# CITY OF ALBUQUERQUE

**RE: 3030 Todos Santos St NW  
Grading and Drainage Plan  
Engineer's Stamp Date: 12/19/25  
Hydrology File: G10D029J  
Case # HYDR-2025-00434**

| ENGINEER'S SEAL            | <b>LOT 3 PH. 1 VOLCANO BUSINESS PARK</b><br>3030 TODO SANTOS NW<br><b>GRADING AND DRAINAGE PLAN</b> | DRAWN BY<br>DEM      |

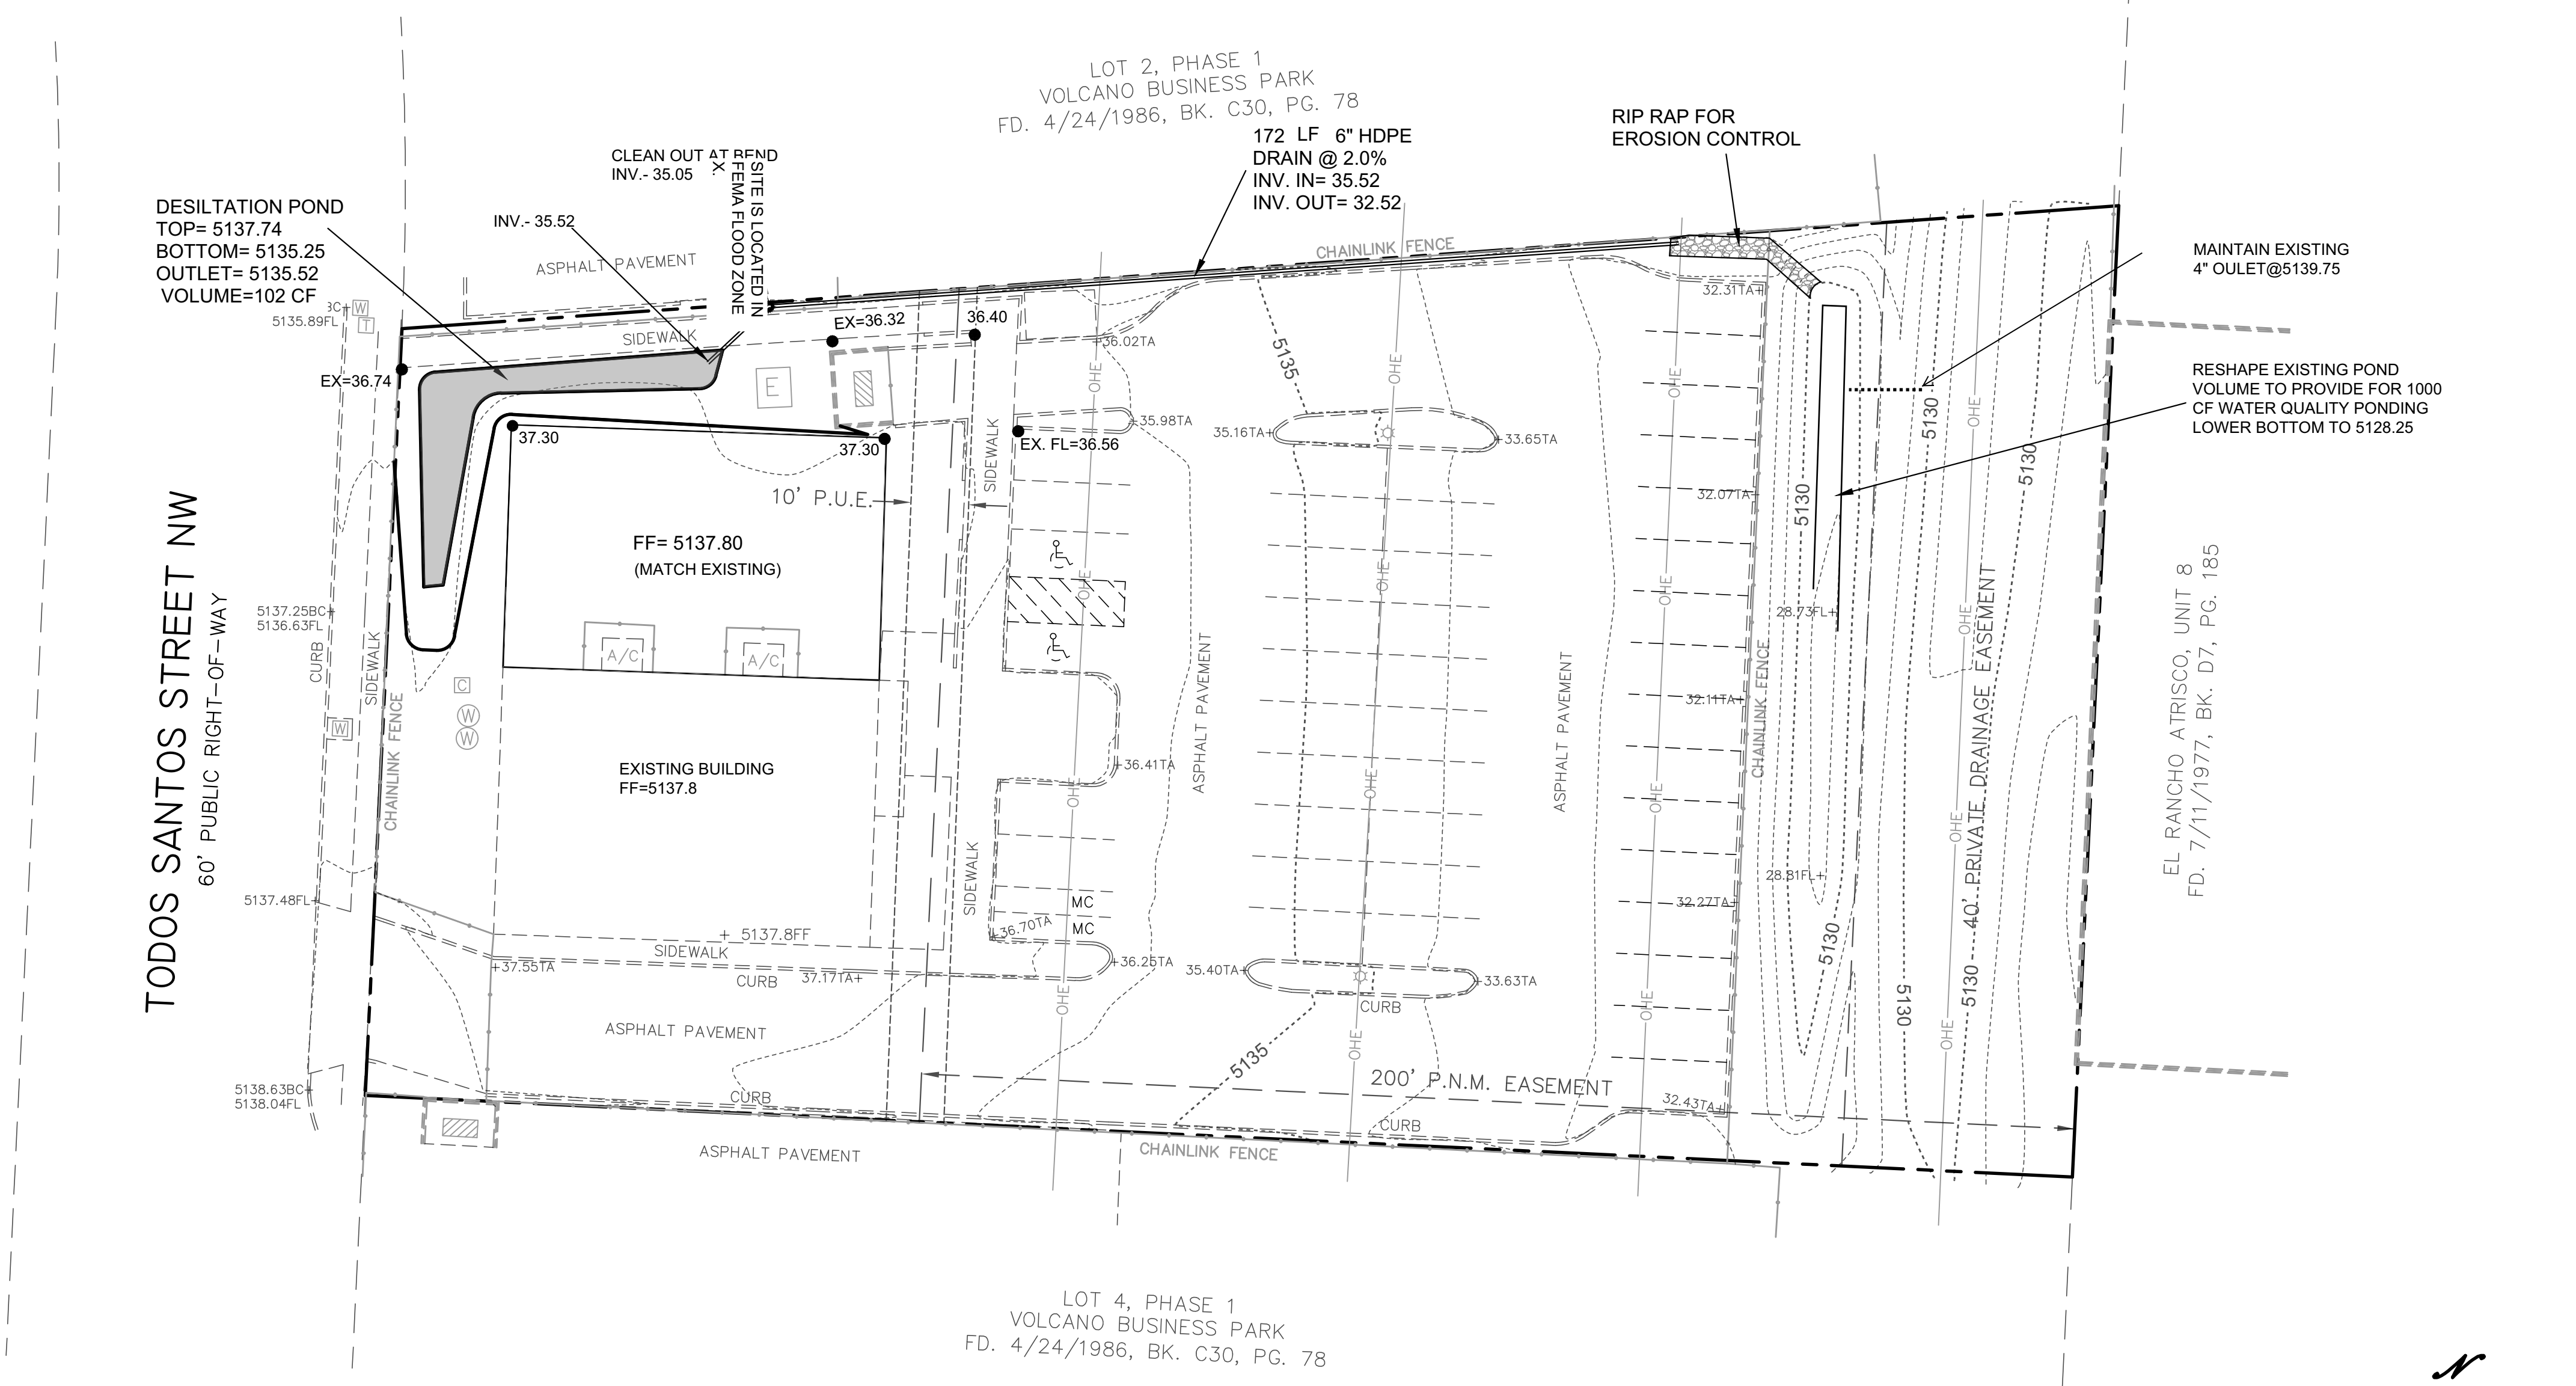
Based upon the information provided in your submittal received 12/22/2025, the Grading and Drainage Plans are approved for Building Permit. Please attach a copy of this approved plan in the construction sets for Building Permit processing along with a copy of this letter.

1. Engineer's Certification, per the DPM Part 6-14 (F): Engineer's Certification Checklist For Non-Subdivision is required.
2. Please provide the Drainage Covenant with Exhibit A for the stormwater quality ponds per Article 6-15(C) of the DPM prior to Permanent Release of Occupancy. Please submit the original copies along with the \$ 25.00 recording fee check made payable to Bernalillo County to the Hydrology Section of Development Review Services on the Ground floor of Plaza de Sol. Submittal in ABQ-PLAN is also required.
